IDAP REPORT

Property:	21 Ravenna Street STRATHFIELD DA 2021/90
Proposal:	Demolition of existing structures and construction of a dwelling house with basement, in-ground swimming pool, deck, outbuilding containing bathroom and sauna, front fencing and associated landscaping works.
Applicant:	H Ye
Owner:	T P Ho & T N Nguyen
Date of lodgement:	10 May 2021
Notification period:	14 to 28 May 2021
Submissions received:	Nil
Assessment officer:	J W Brown
Estimated cost of works:	\$947,300.00
Zoning:	R2-Low Density Residential - SLEP 2012
Heritage:	No
Flood affected:	No
Is a Clause 4.6 Variation Proposed:	No
RECOMMENDATION OF OFFICER:	Approval

Figure 13: Front fence facade

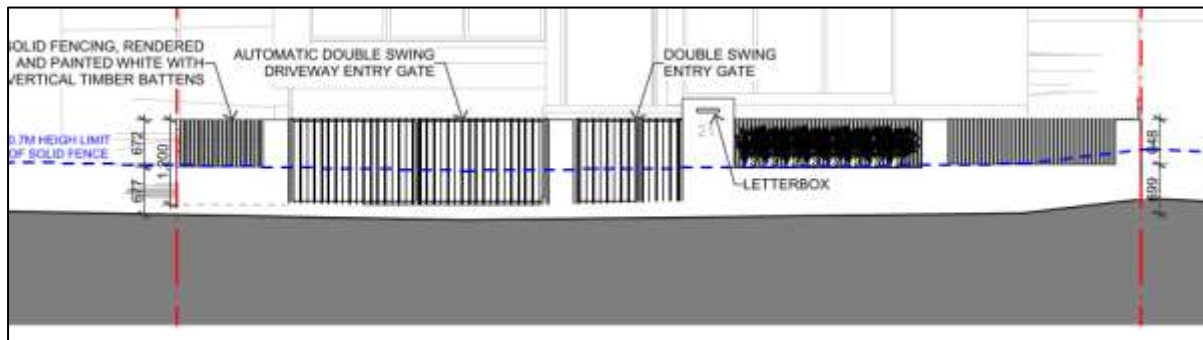
The proposed front and side fencing satisfies the relevant objectives and most of the controls within SCDP 2005. The letterbox within the pier structure breaches the required

height of 1.5m by 200mm. This is a decorative element of the front fence that ensures that the letterbox is easily identified. The rest of the front fence complies with the maximum height requirement of 1.5m. Overall the front fence is considered to be sympathetic to the existing and desired character of the locality and is compatible with the height and style of adjoining fences.

Figure 14: Basement height out of ground non-compliance

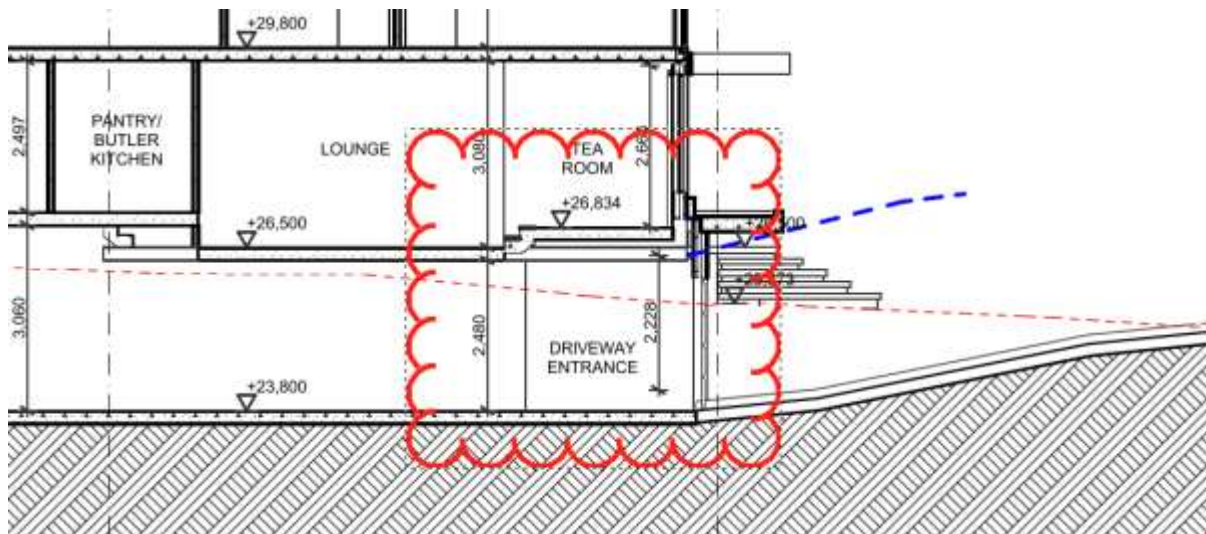
The proposed development satisfies the relevant objectives and controls of the SCDP 2005 in that it provides the minimum number of required parking spaces and adequate vehicular access provisions. The tea room's floor level creates a point encroachment whereby the basement extends beyond the required 1m above natural ground level requirement. This is due to that the land slopes from the rear to the front boundary and the dwelling follows this contour and steps up in the rear. A condition is recommended to lower the tea room FFL by 250mm. To ensure that the basement will be compliant with 1m above ground level control.

The basement has been designed so that vehicles can enter and exit in a forward direction, A condition of consent is recommended to ensure that the minimum internal clearance height of 2.2m as specified by the SCDP 2005 is achieved by the design. The driveway at the property boundary has been conditioned to be 3m in width to comply with Clause 8.2.2 of

the SCDCP 2005. The rest of driveway and ramp being 3.6m is acceptable as it is only 100mm increase on required 3.5m. This minor non-compliance will have limited impact on the visual aesthetic of the proposal. The design of the basement is acceptable and is within building footprint of the dwelling, it is also setback appropriately from all boundaries
